September 19, 2024

**RE: Pinnacle Bellevue North
Project #: 21-103195-LD; 21-103192-LP
Revision Request #6**

The Development Review Committee (DRC) has reviewed the plans submitted on July 15 - 16, 2024 for the Administrative Design Review, file number 21-103195-LD and Master Development Plan, file number 21-103192-LP. Below are additional comments and revision requests from the City's review team. **Please note that additional information may be requested as a result of our review of your resubmittal.**

Green and Sustainability Factor (Sheet LA 404)

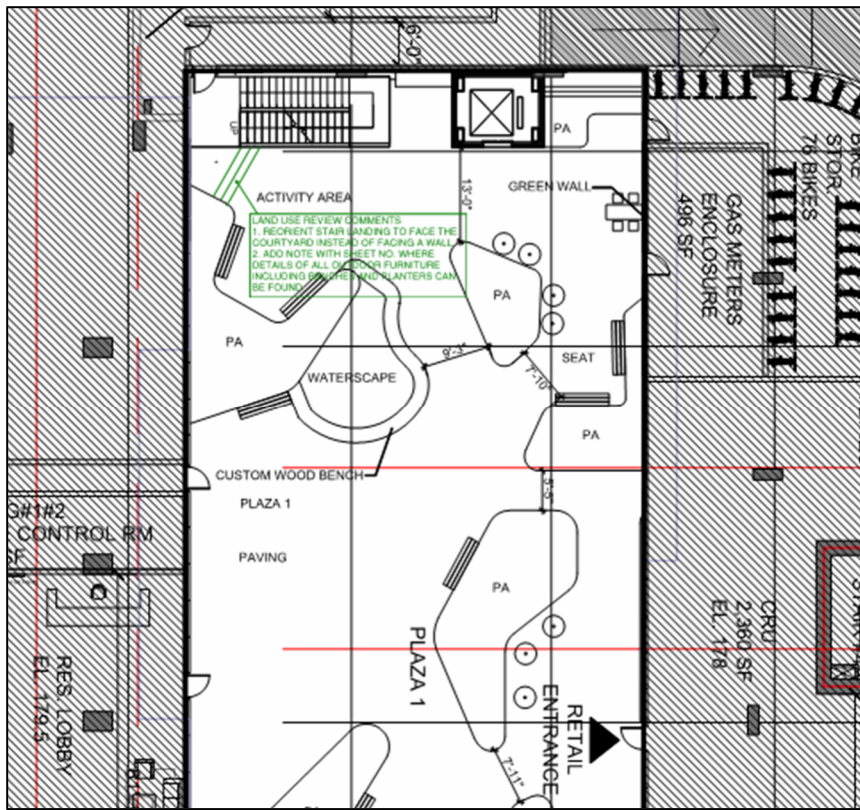
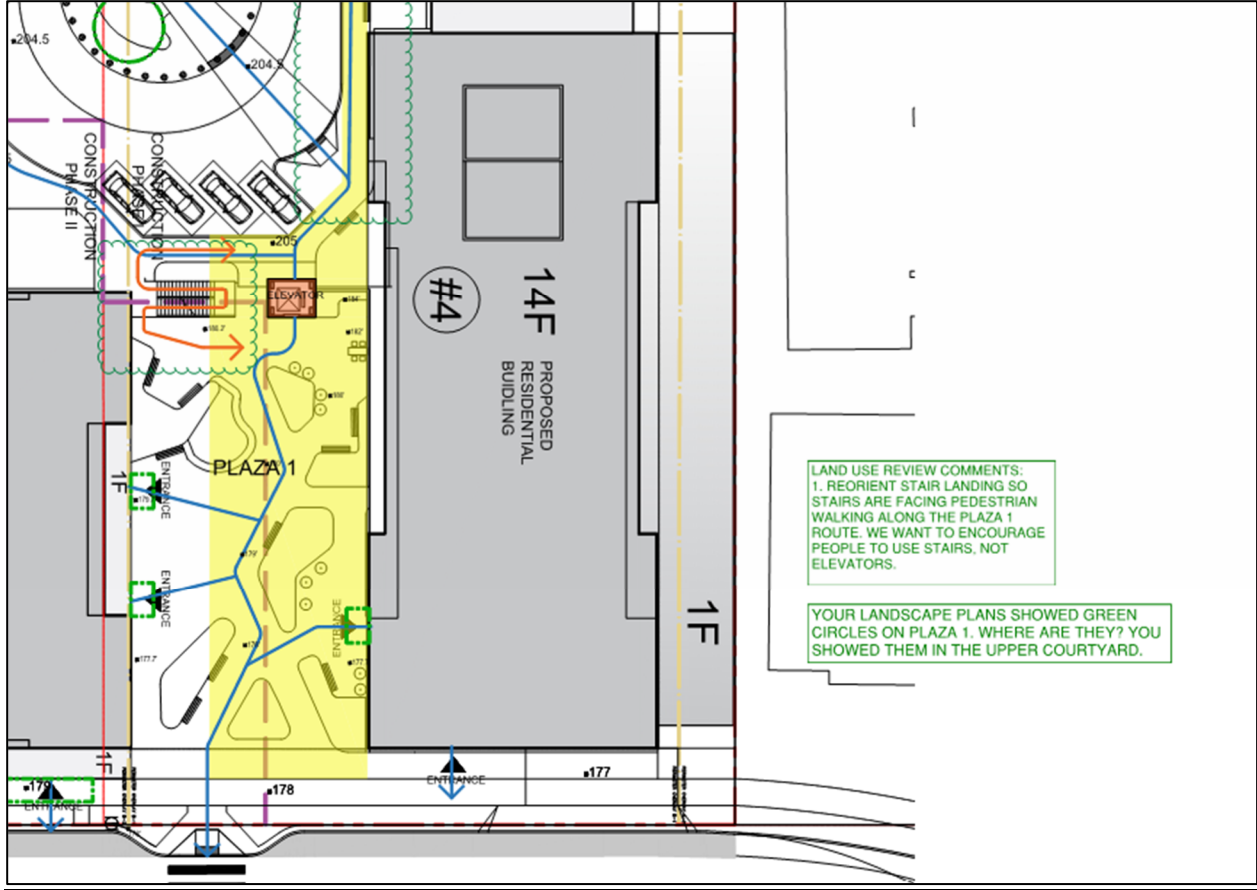
1. On the Plant Schedule landscape plan sheets, identify which plants are being used to meet your Green and Sustainability Factor. The total number of plants shown on the Plant Schedule for meeting the Green and Sustainability Factor must clearly match the total numbers on the Green and Sustainability Factor Worksheet.
